RE: Bid Title: Construction of Leon County Public Library Eastside Branch
Bid No: BC-06-08-10-33
Opening Date: Tuesday, June 8, 2010 at 2:00 PM

ADDENDUM #3

This letter serves as Addendum #3 for the above referenced project.

1 FLOOR PLAN - SEE STRUCTURAL FOR LAYOUT
A1.1 1/8" = 1'-0"

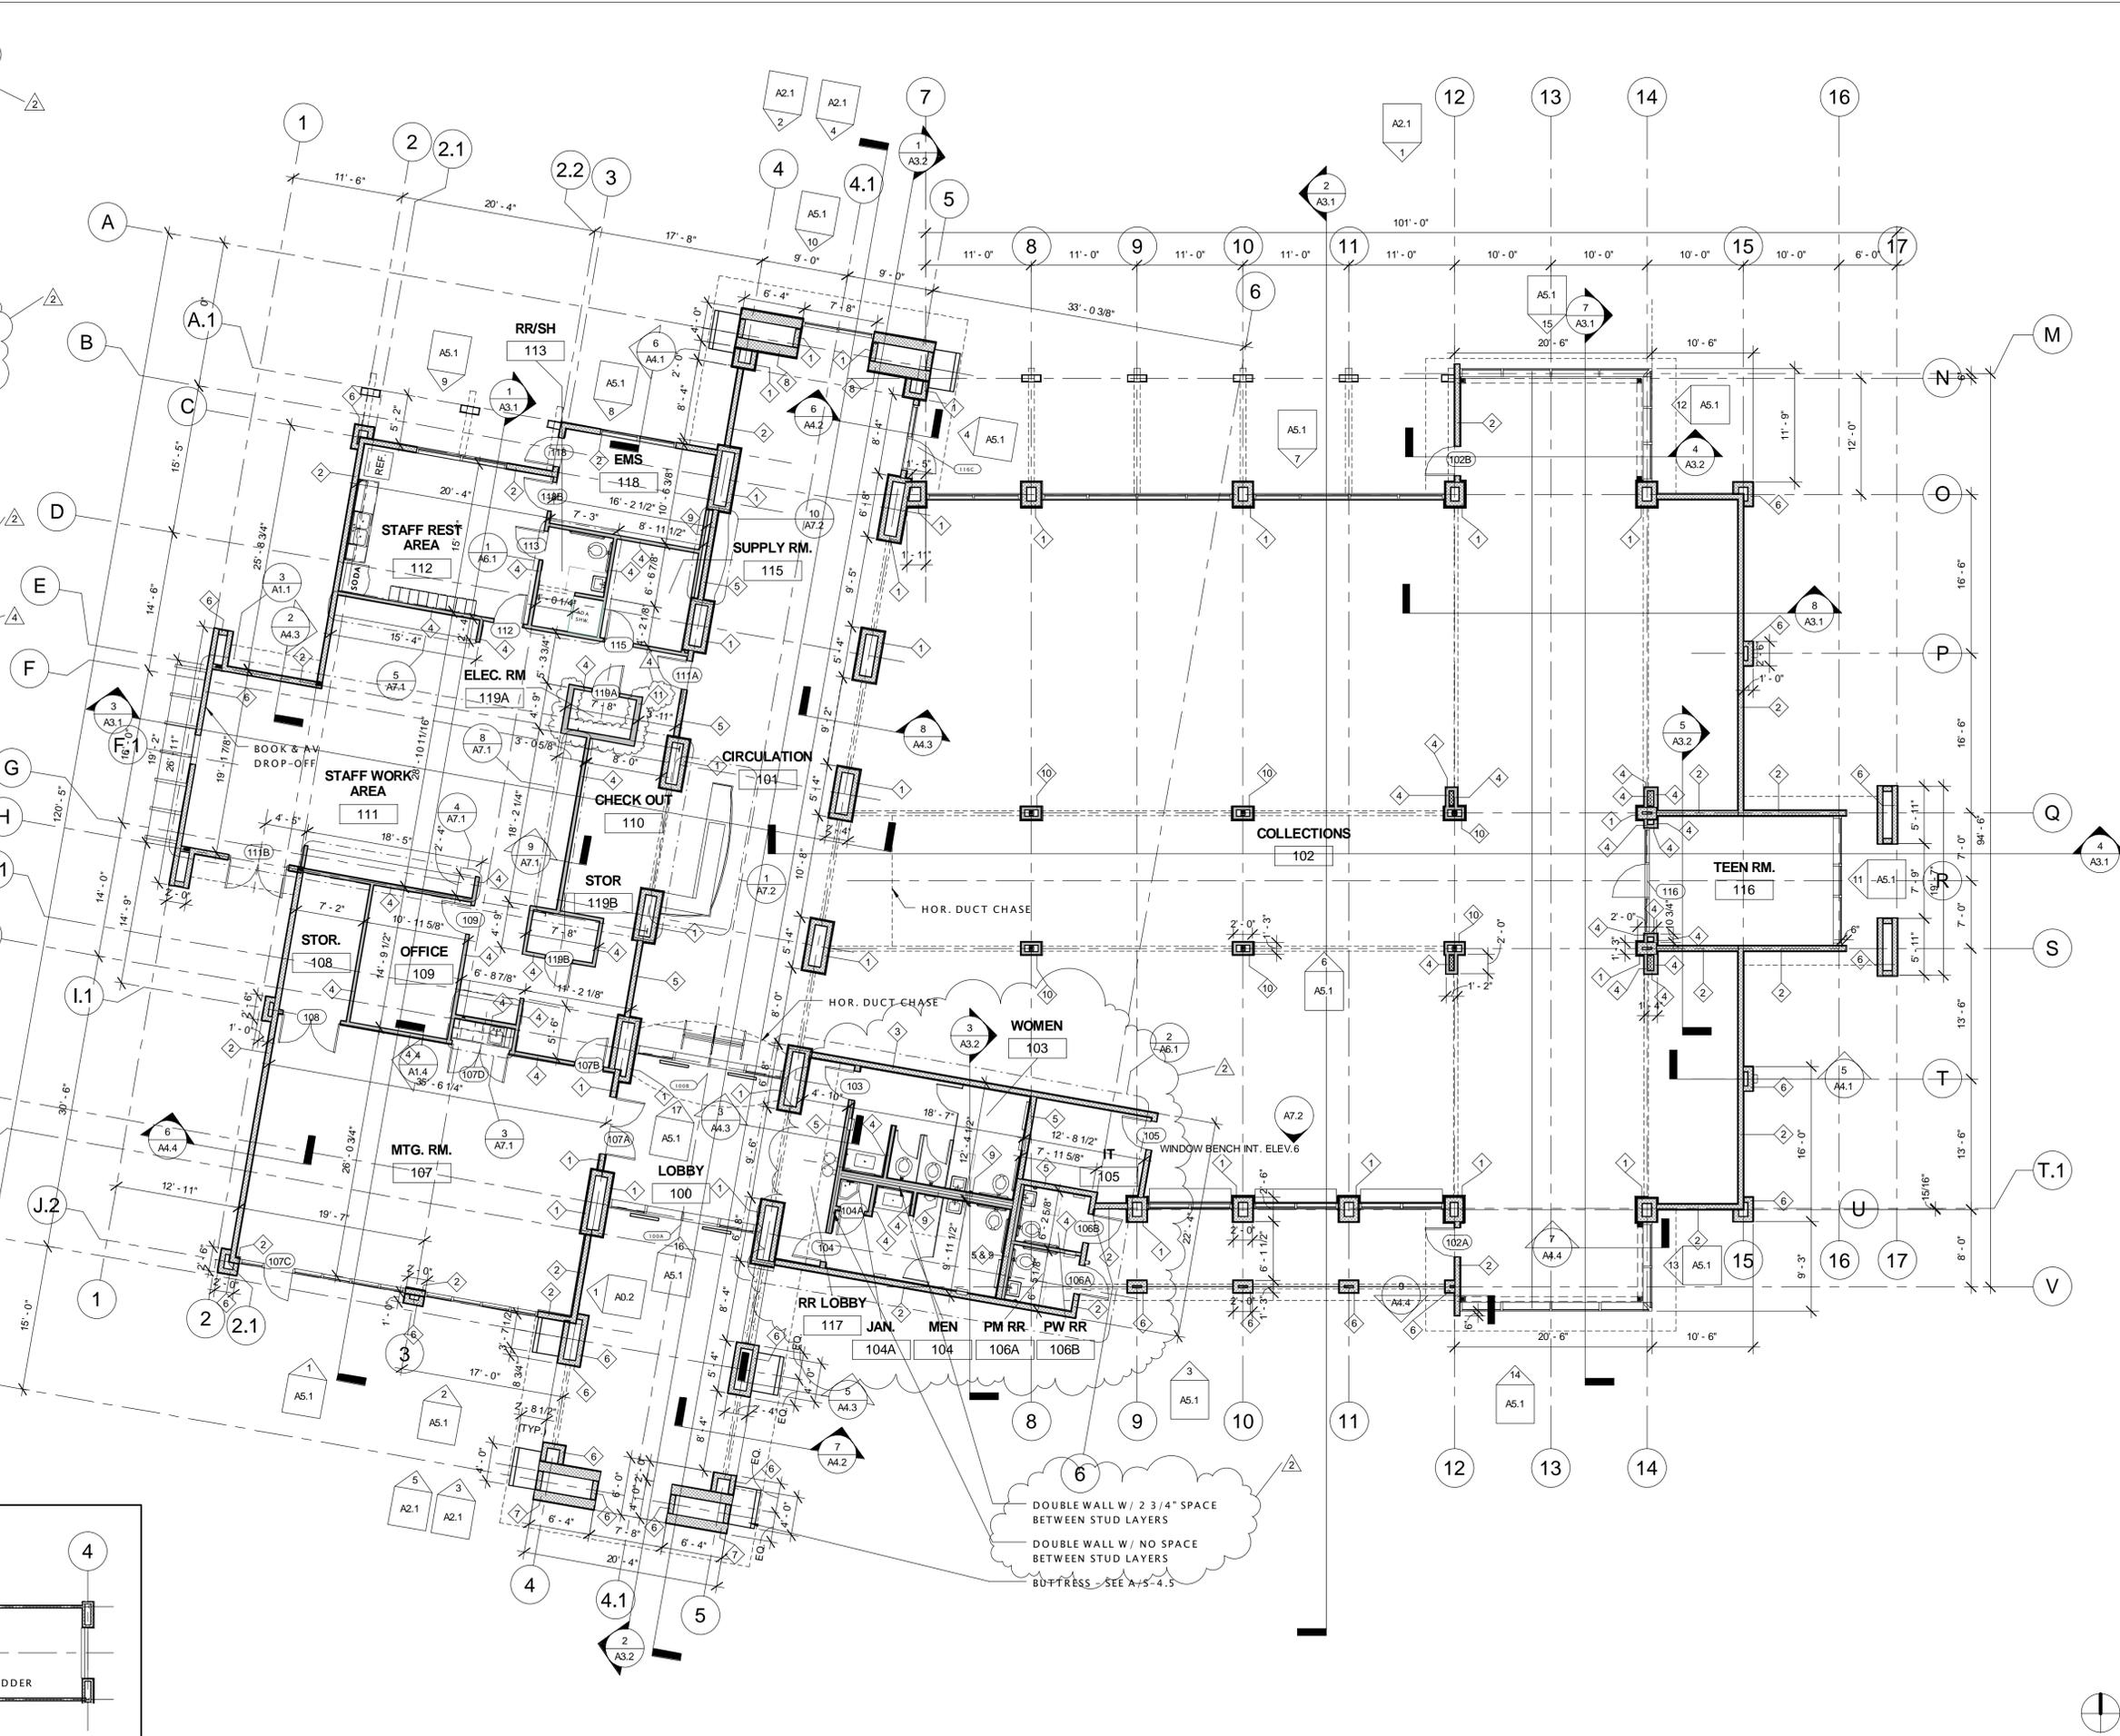
- A17:** *Reference Architectural Sheet A1.1. – Room 119A walls have been modified to show 6” metal stud walls.*

STEEL LAYOUT & MEZZANINE PLAN
SCALE 1/8"=1'-0"

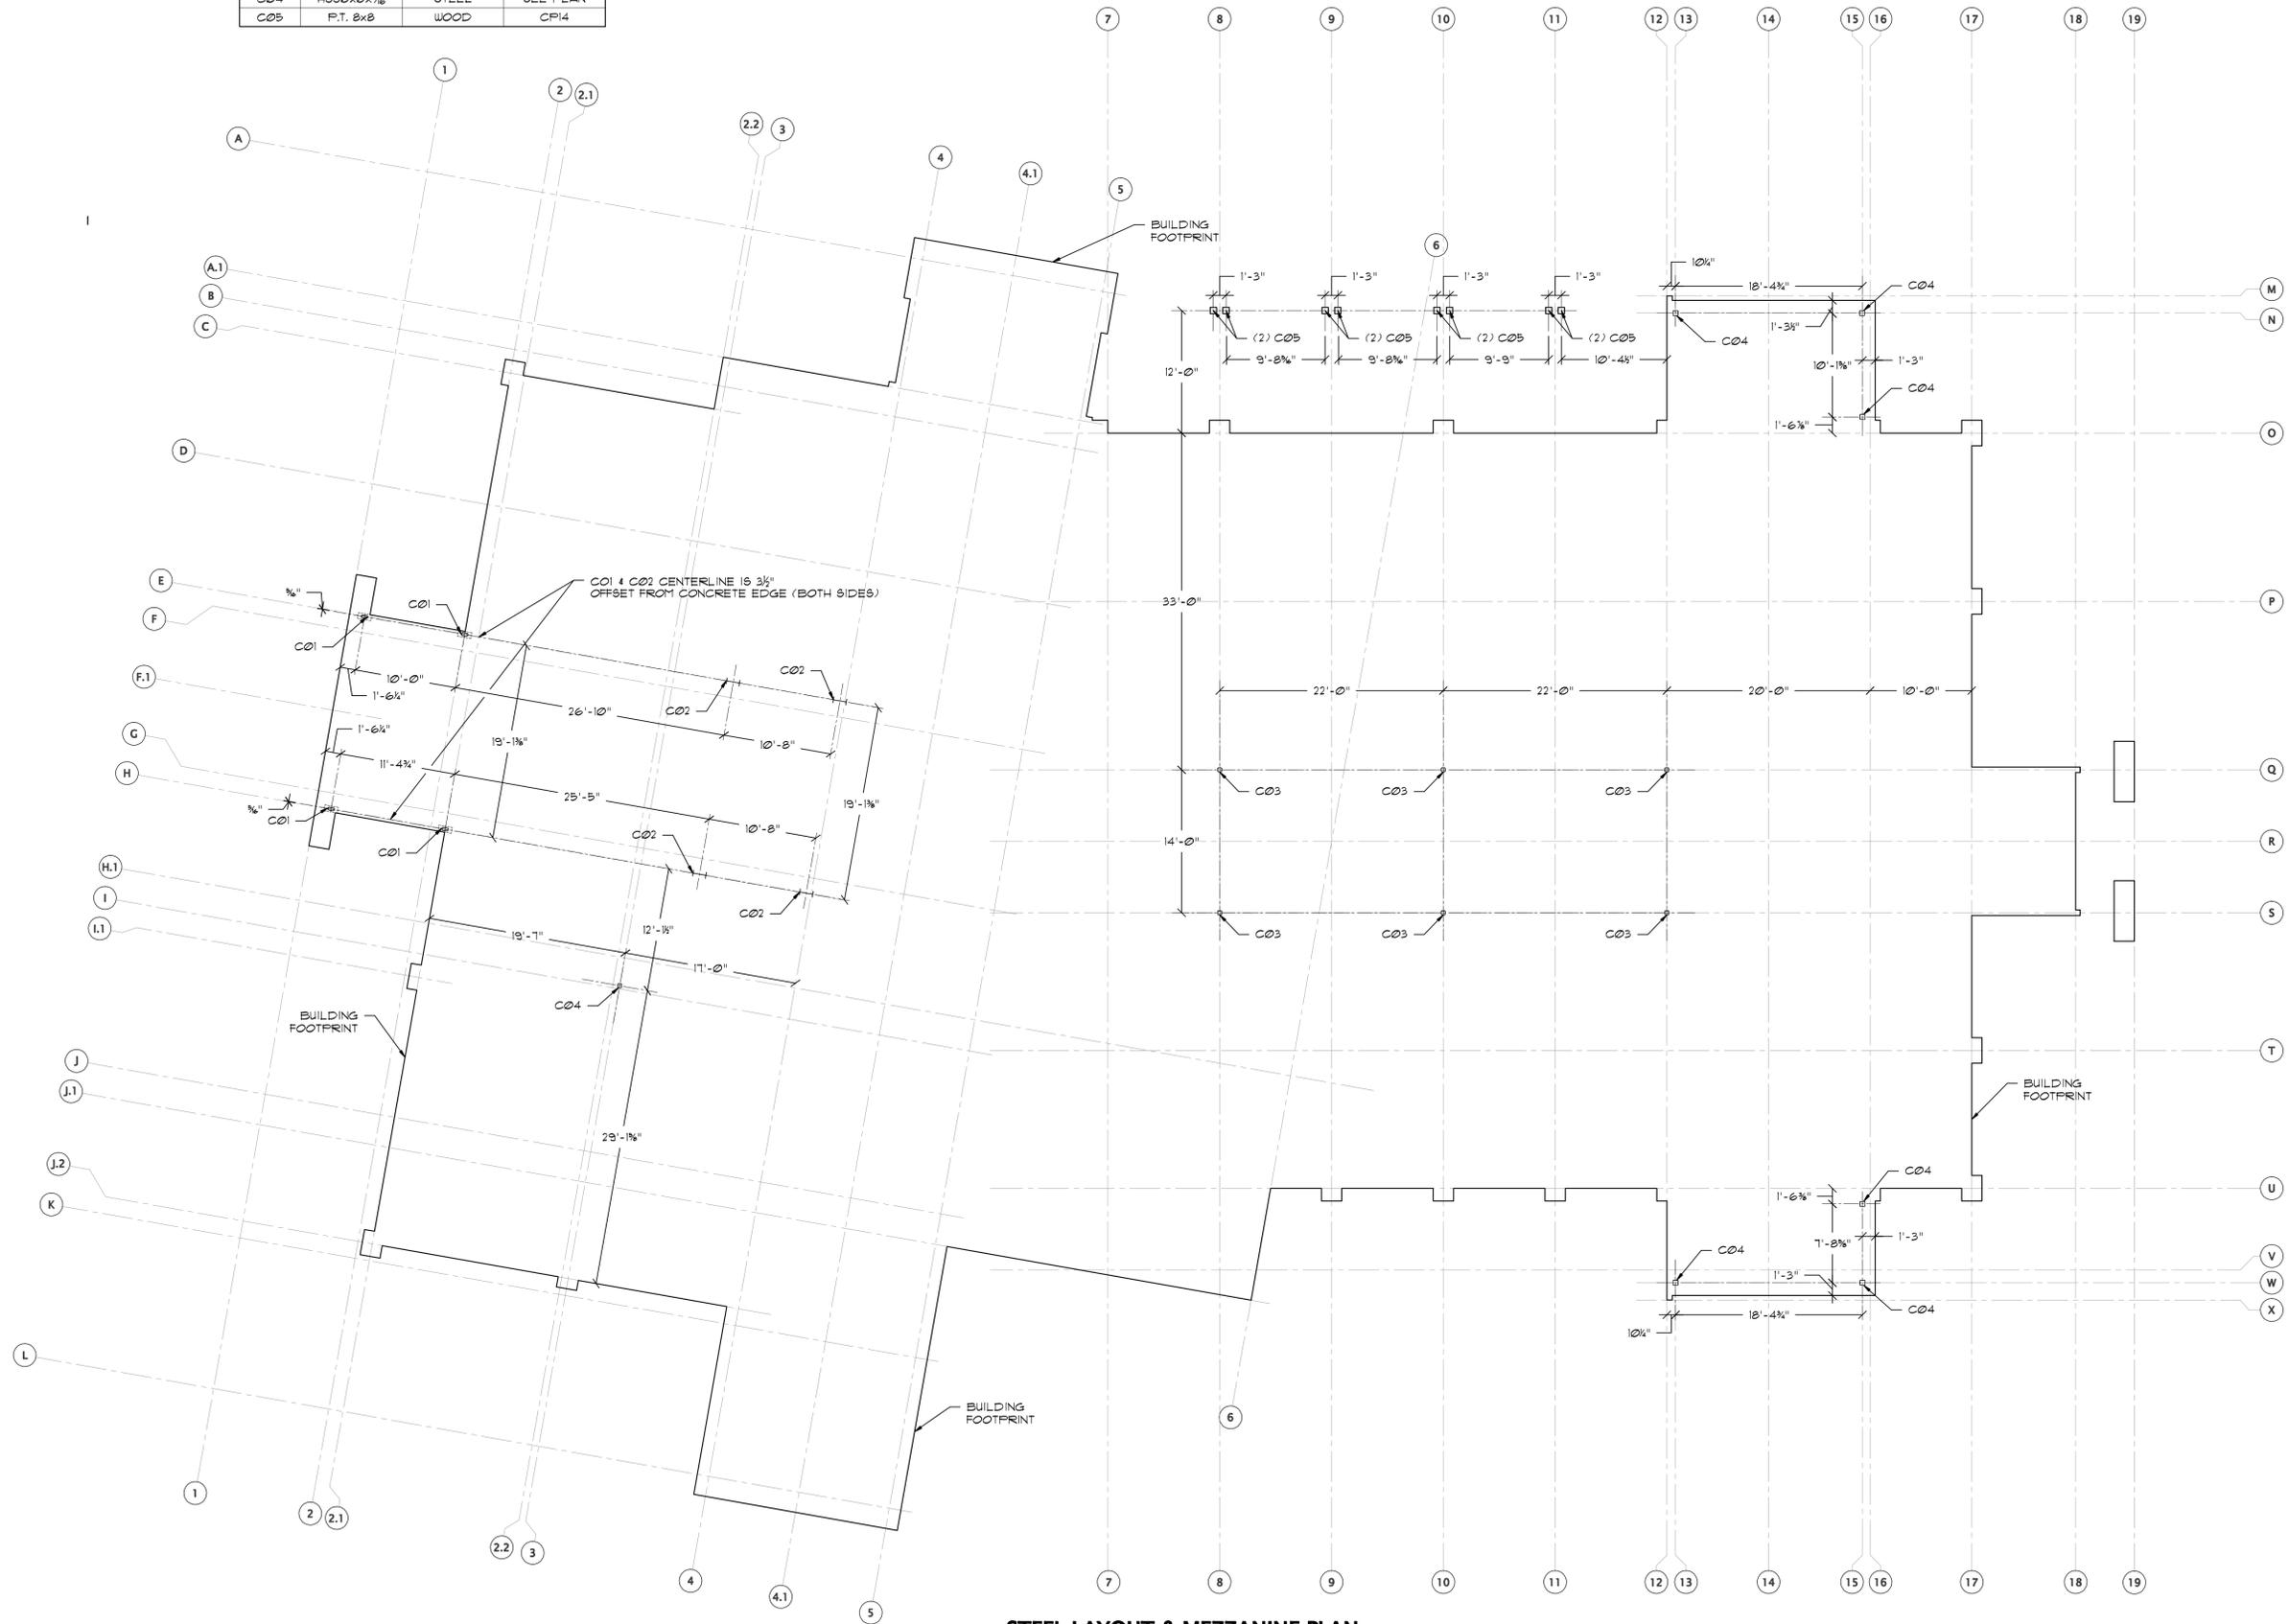
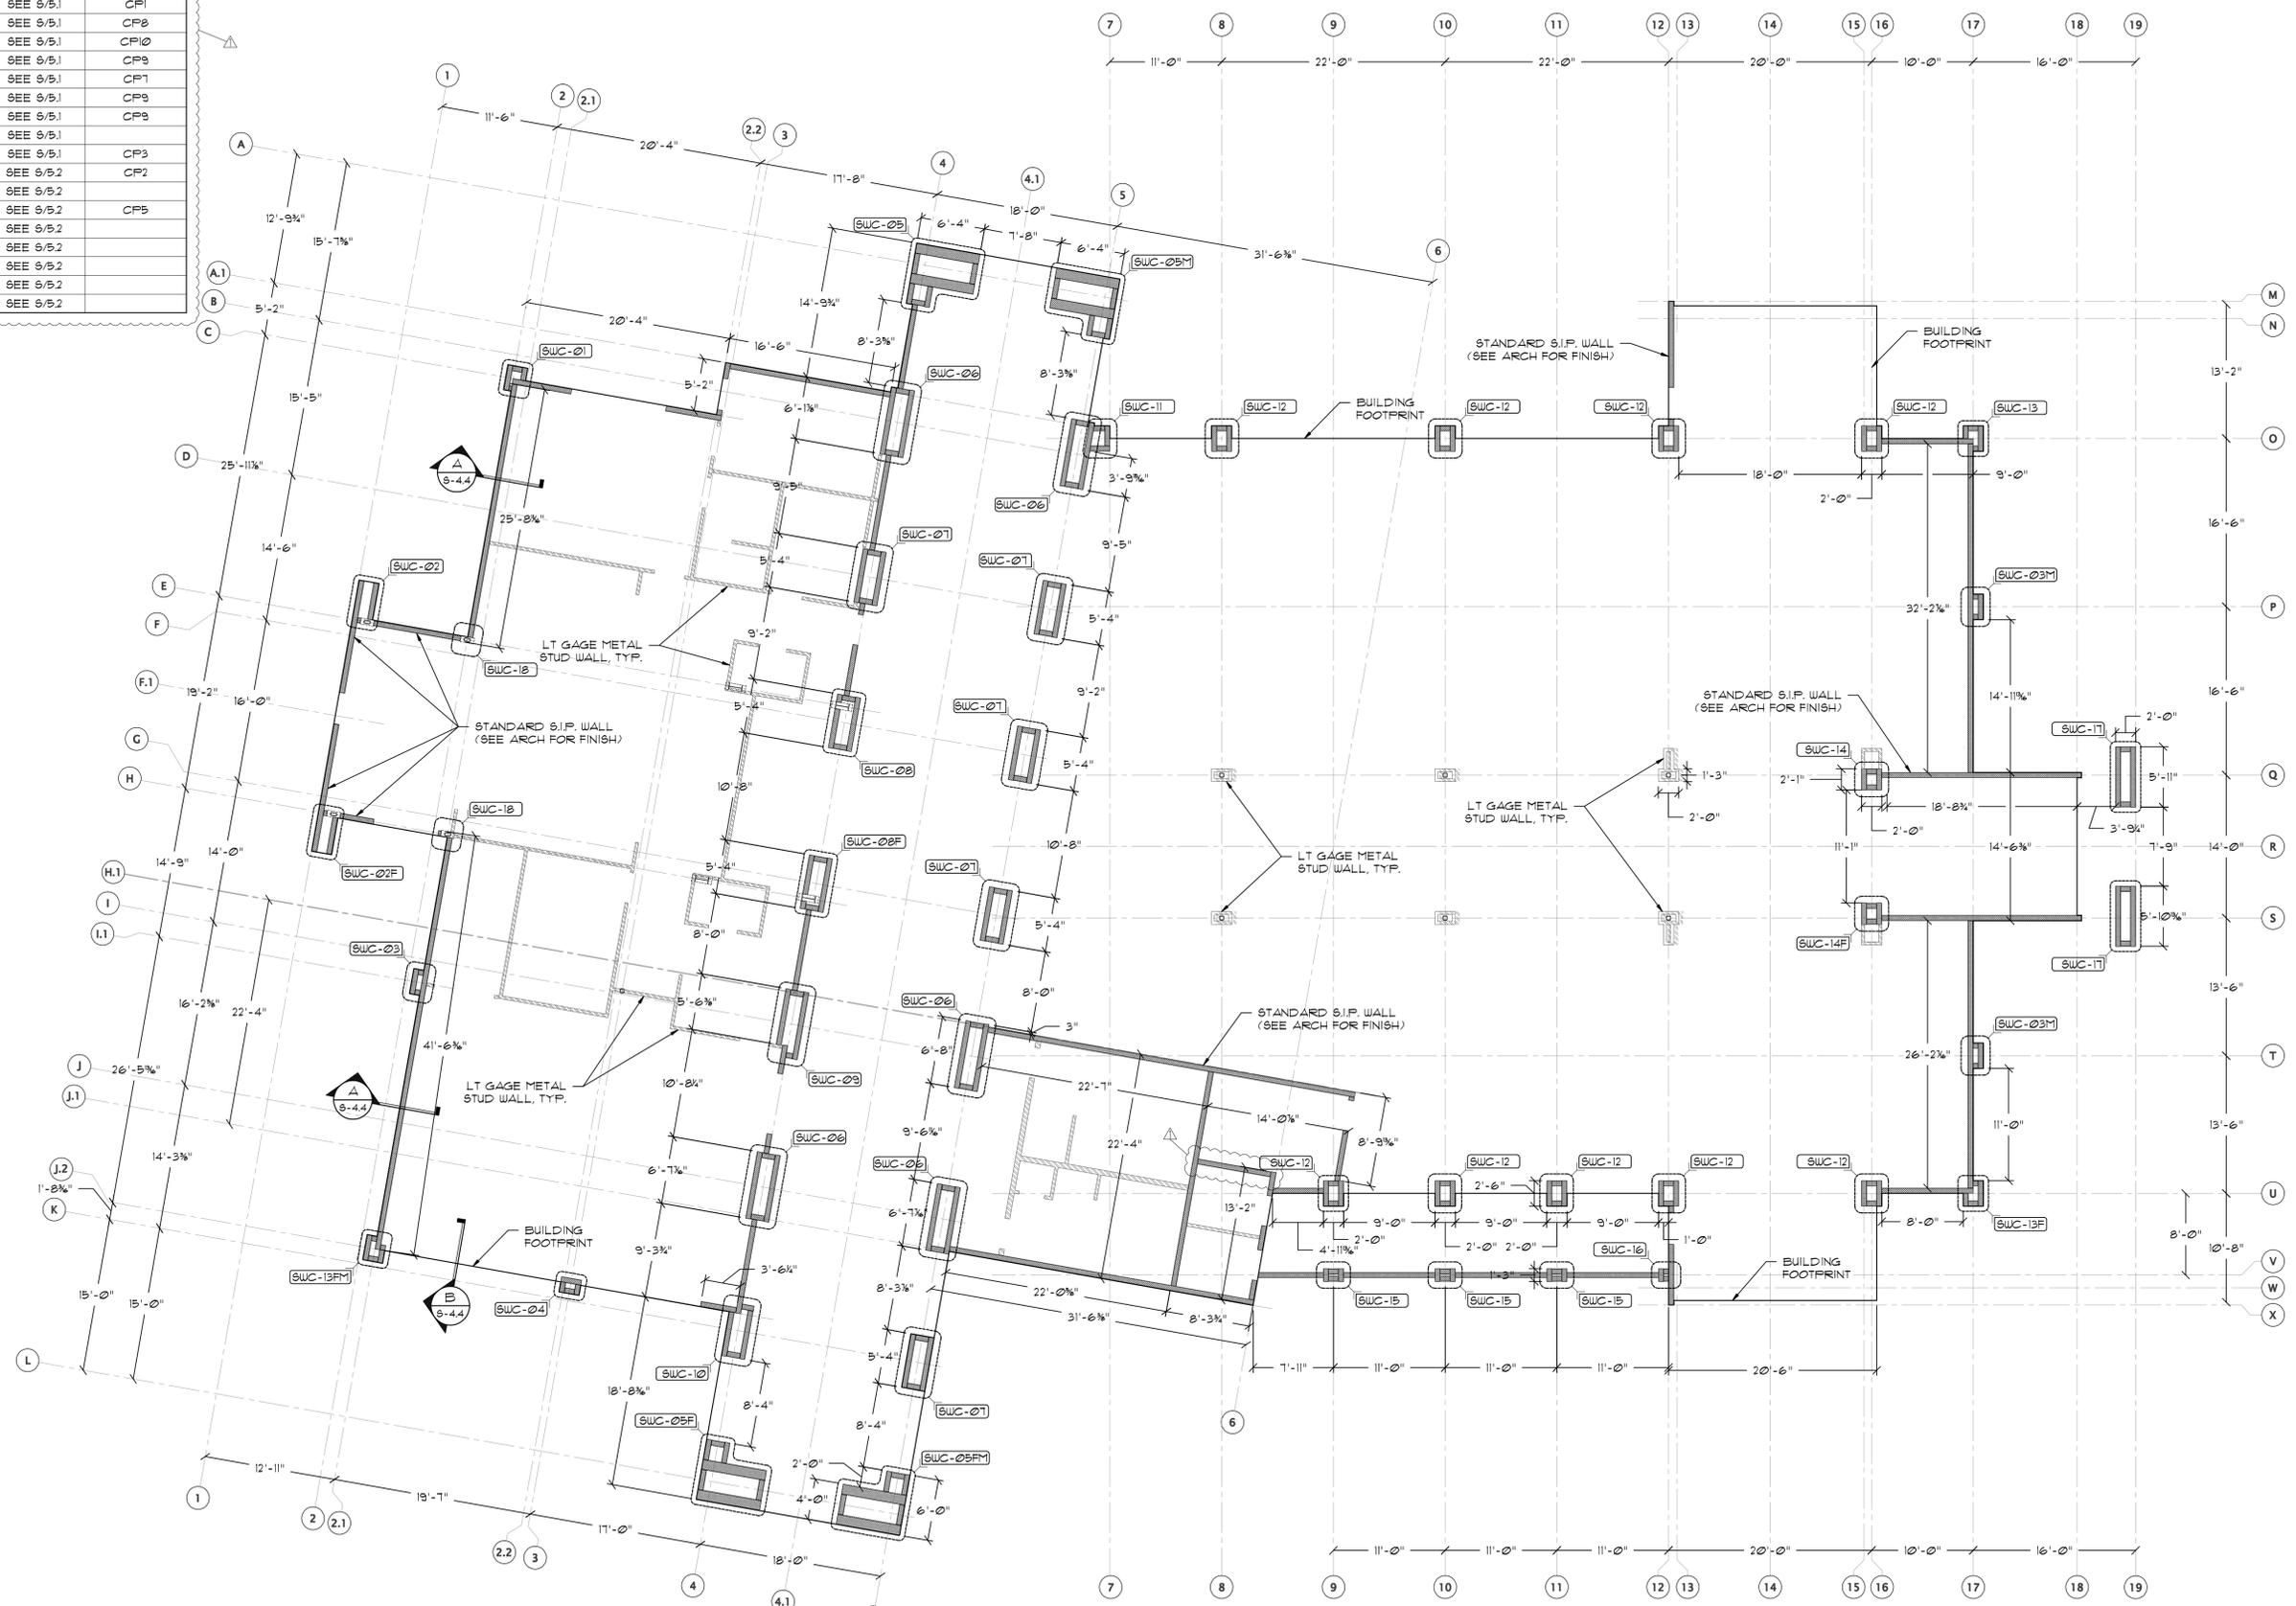
S1: *Reference Structural Sheet S-1.1.* – Column lines 3, 5, 9, 10, 11, 12, 13, 15 and 16 have been modified to show CP designations. See attachment.

S1: *Reference Structural Sheet S-1.1, S-1.2, S-1.3, S-1.4, S-1.5 & S-1.6.* – Drawing have been modified to shown the scale. See attachment.
